**Amendments to the Drawings:**

### **REMARKS/ARGUMENTS**

Schematic 1

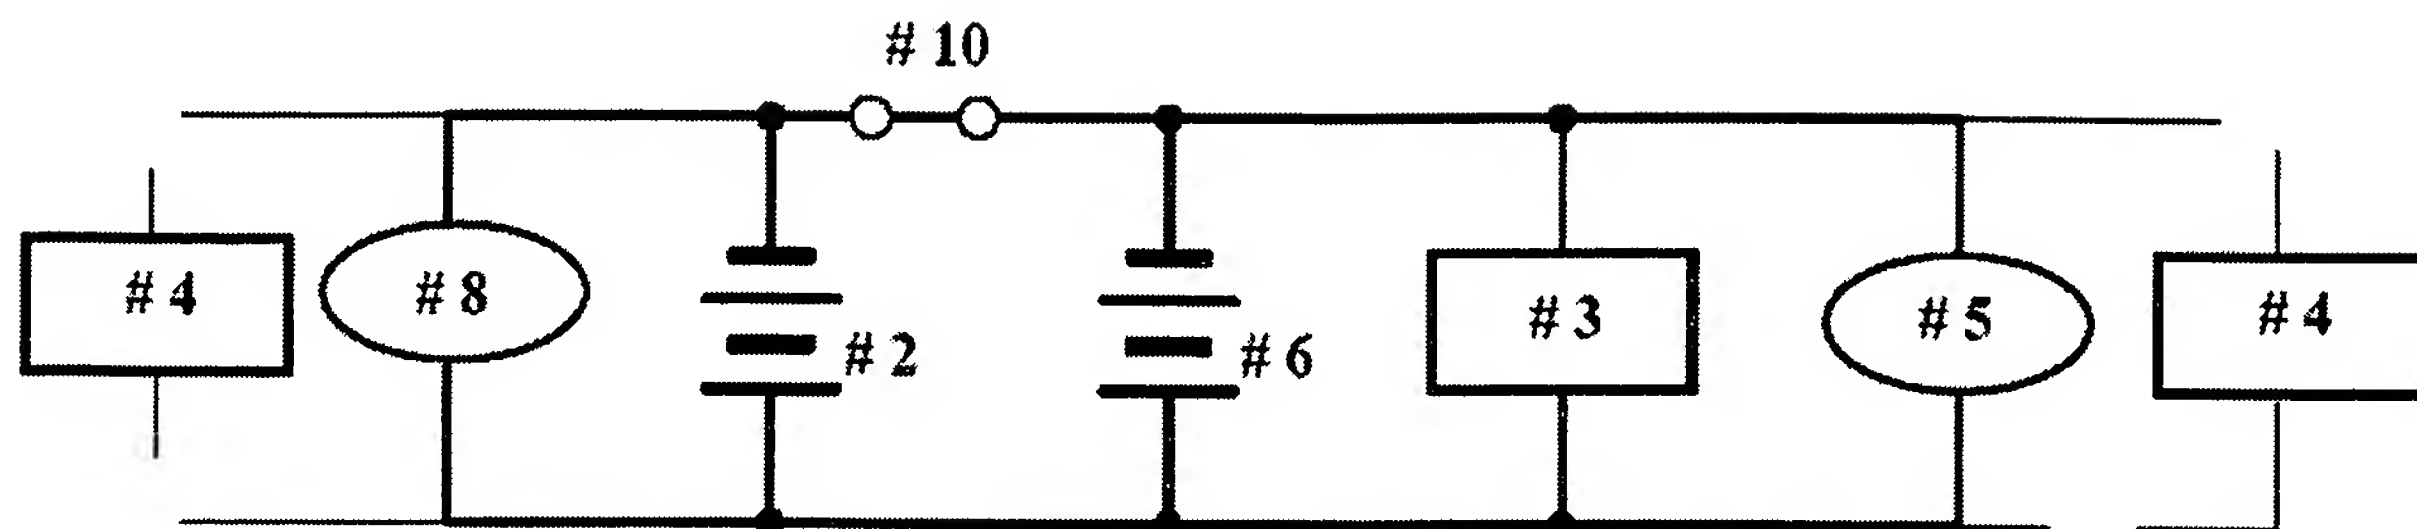
The starting mode or operation for *all* embodiments disclosed in Dierker (FIGs. 1-6) simplifies to an identical electrical schematic of a basic parallel boost system as shown below in Schematic 1, which is presented here without discussion of the charge balancing between the starter battery 2 and the vehicle electrical system battery 6 and the MOSFETS and ancillary switches as are presented in FIGs. 3-6 of Dierker but which have no effect on the startup operation. (See col. 2, lines 45-60; *see also* Weiss Decl. ¶ 6.)

Each embodiment has several switches 7, 9, 10, 12, 13, 14 that are selectively closed at engine startup as summarized in the table below, with annotations to the appropriate line and column numbers of Dierker indicating the position of each respective switch at startup. (Weiss Decl. ¶ 7.) As evident from the schematic above and the table below, **both** the vehicle electrical system battery 6 and the starter battery 2 are connected *in parallel* and *simultaneously* supply DC power to the electrical system loads 3, 4, 5, 8 at engine startup, which is diametrically opposite to the recitations of Applicants' newly presented claims.<sup>1</sup> (*Id.*)
